**SEQUOYAH NUCLEAR PLANT (SQN) - REVISED RESPONSES TO NRC  
QUESTIONS 1, 2, and 3 FOR TECHNICAL SPECIFICATION (TS) CHANGE  
00-14, "PRESSURE TEMPERATURE LIMITS REPORT (PTLR) AND REVISED  
TOPICAL REPORT (WCAP-15984, REVISION 1), REACTOR CLOSURE  
HEAD/VESSEL FLANGE REQUIREMENTS EVALUATION FOR SEQUOYAH UNITS  
1 AND 2" (TAC NOS. MB6436 AND MB6437)**

### SEQUOYAH NUCLEAR PLANT (SQN) REVISED RESPONSES TO NRC QUESTIONS 1, 2, AND 3

#### TECHNICAL SPECIFICATION (TS) CHANGE NO. 00-14, DOCKET NOS. 50-327 AND 50-328

**Figure 1-1 Finite Element Model for Closure Head Region, Sequoyah Units 1 and 2**

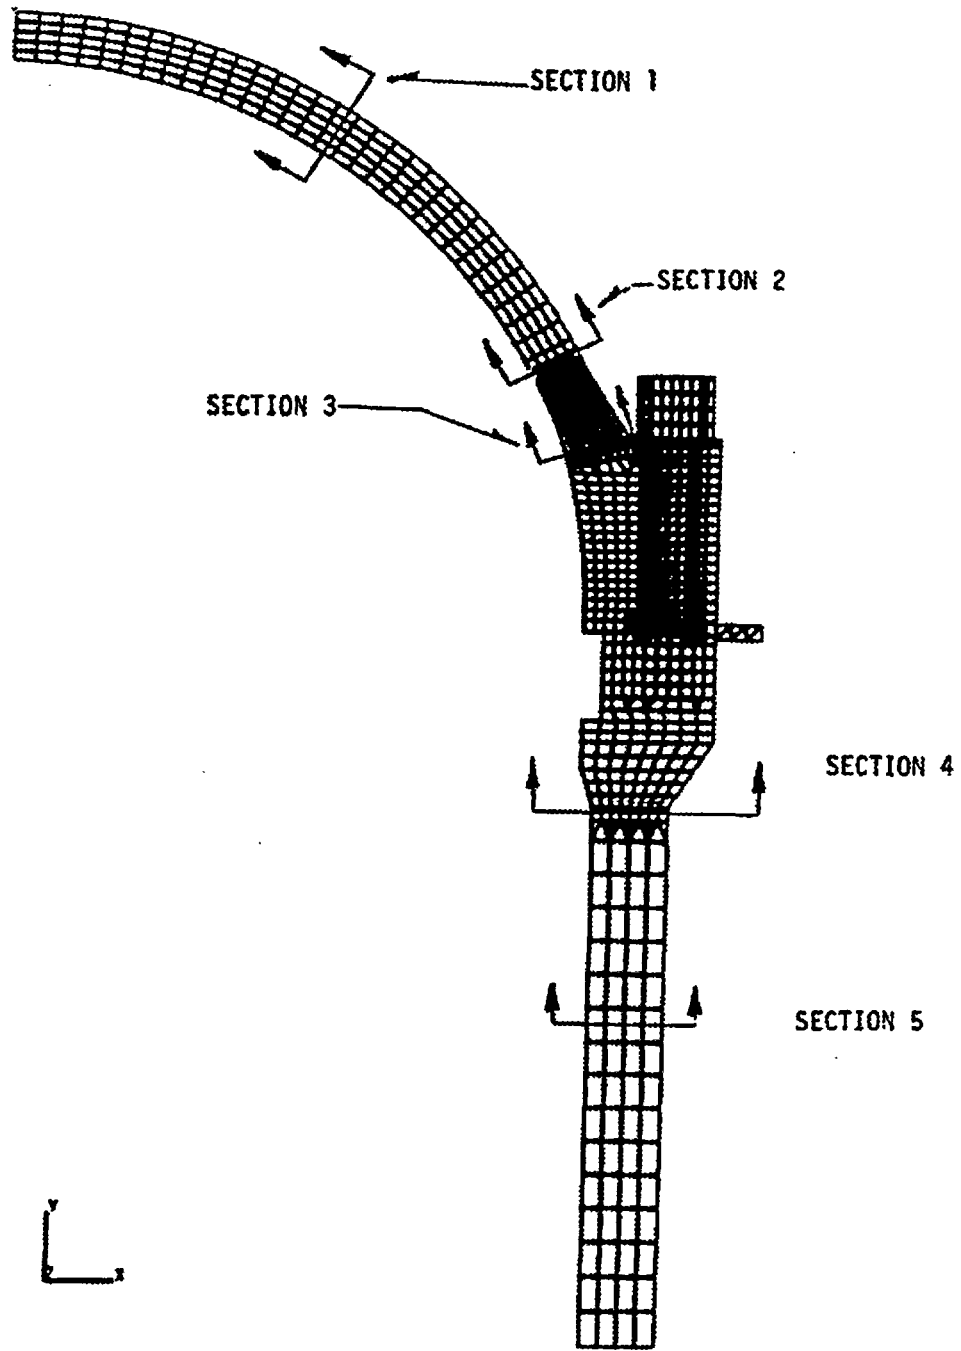
Regarding the discussion on page 4-1, "These results [the stresses for boltup and steady-state operation given in Table 4-1] were taken from a finite element analysis of the heatup/cooldown process, and the boltup was determined to be the most limiting time step for the entire heatup/cooldown transient."

Provide a summary which identifies how the finite element analysis (FEA) was performed, including important analysis variables (e.g., mesh size/element used, convergence criteria, thermal transient time step magnitude, boundary conditions, etc.). The level of detail provided should be such that the U.S. Nuclear Regulatory Commission (NRC) staff will have reasonable assurance regarding the acceptability of the licensee's FEA process and input variables. Provide stress analysis results consistent with the level of detail provided in Table 4-1) and through wall temperature distributions at twenty evenly distributed points along the most limiting heatup/cooldown transient which was analyzed.

The stress analysis was performed using an axisymmetric model shown in the cross section in Figure 1-1, where the cross section of interest is highlighted as Section 3.

There are 54 studs that join the reactor vessel head to the closure flange. These studs are equally spaced around the vessel. Two-dimensional axisymmetric elements were used to model the closure flange region of the reactor vessel. There are a total of 996 elements and 1139 nodes in the model.

Physically, the reactor vessel shell will displace laterally, and the crown of the head does not displace laterally. To approximate this behavior, the bottom surface of the model in the shell region and the vertical surface of the model at the vessel crown were both assumed to be resting on rollers. This arrangement of restraint is assumed to correspond to the actual behavior of the vessel and prevents any rigid body motion of the model.

point. In keeping with this assumption, the head and shell are mechanically coupled only at one corner node nearest the studs to allow completely free rotations.

Choosing to couple mechanically at only the pivot location, as discussed above, should tend to increase the bending stresses at all the selected Sections 1 through 5 shown on Figure 1-1. Mechanical coupling at more than one node, or all the nodes on the flange mating surface would have prevented free rotation of the flanges and reduced the bending stresses.
